SOLV/EDC & CMP PLANT NOTIFICATION OF PROCESS CHANGE CHECKLIST

Description and Location of Change (Scope): Replace the 1 1/2" x 1 1/2" x 1/2" ARC valves for P-1250 A/B with 2" x 2" x 1" ARC valves.

Project Title	P-1250 A/B ARC Valve Replacement		
Project Description and Economic Bases	The existing automatic recirculation control (ARC) valves for P-1250 A/B are undersized, causing the pumps to operate at an unstable minimum flow during pump swaps and startups. This leads to failures of the mag drive pumps which cost on average \$25,000/yr. This project will provide for labor and material to install larger ARC valves.		
Net Project Cost	10	M\$	
Project Stage	2	+35% / -20%	
Benefits Estimate	28	M\$/yr	
Capital / Expense	Expense		
Project Number	Expense	XXXXX	
Completion Date	Dec-97		
Date of last update	1-Mar-96

General layout and overall dimensions

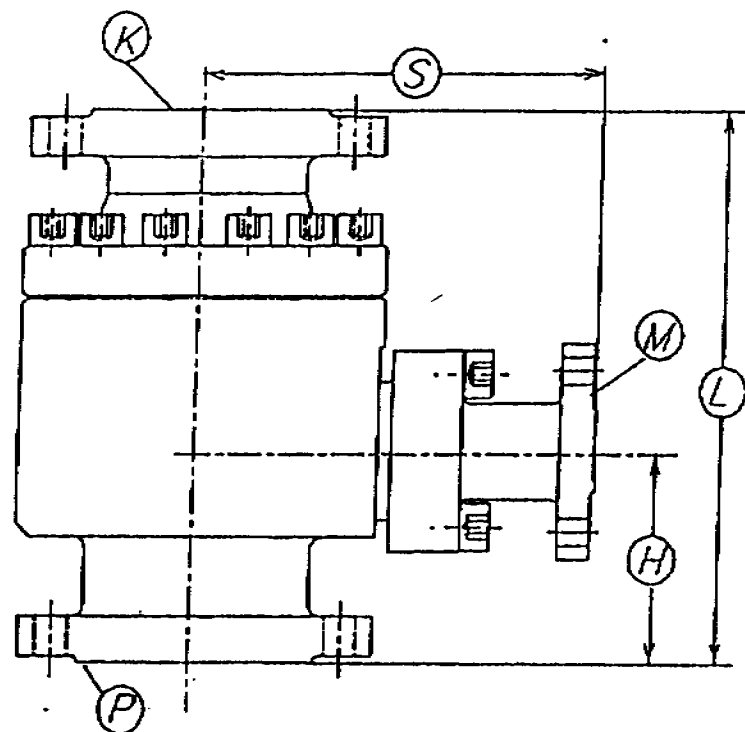
Technical Basis for Change: Existing ARC valves are designed for a minimum pump flow (recycle) of 20 gpm. Klaus-Union states that the minimum flow should be 42-45 gpm. The new ARC valves will provide the increased flow requirements.

RE: Replacement of SSV10 Series Schroeder valves - ANSI 300
TAG # 1250A/B (1.5"x.5") to be replaced with SSV10 - 2" x 1"
(tagged same)

The SSV10-2" x 2" x 1"/300 Lb. RF flanged valve price is \$2,960.00 each. The minimum flow will be 42 - 45 gpm. The valve will be the identical design of existing SSV10 valve. Delivery is 12-14 weeks., F. O. B., Houston, TX.

Flange rating			Installation dimensions	
	Size	ANSI Class		
P	2"	300 Lb. RF	S	7.087 inches
K	2"	300 Lb. RF	H	3.937 inches
M	1"	300 Lb. RF	L	10.630 inches
			Weight	68 lbs.
